Groundwater Application Review Summary Form

Application # G- 18393

PUBLIC INTEREST REVIEW FOR GROUNDWATER APPLICATIONS

SUBJECT: Application G- 18393 Supersedes review of 04/10/2017
Date of Review(s)

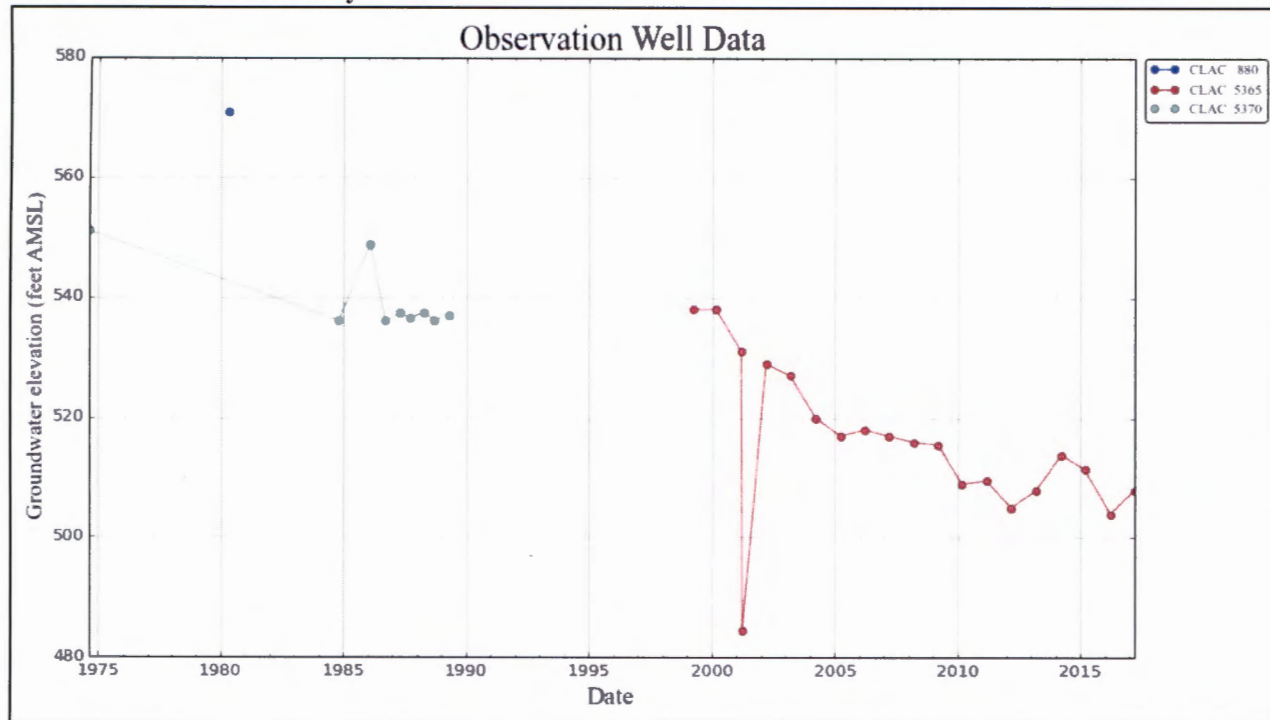
- B3. **Groundwater availability remarks:** Based upon water level data and stratigraphic information from nearby wells within the Sandy-Boring GWLA, the proposed POA well (CLAC 880) produces either partially or completely from the Upper Troutdale Aquifer. Nearby well CLAC 5365 (see attached hydrograph), under permit G-13402 has very similar water levels to the proposed POA well, and was recognized at the time as a possible commingling well between upper and lower Troutdale Aquifer systems (Miller, 1997). Continued measurements within this well display declines, though over the past ten years these declines total less than ten feet. The proposed rate of use is very small (0.025 cfs) and is unlikely to significantly impact nearby users.
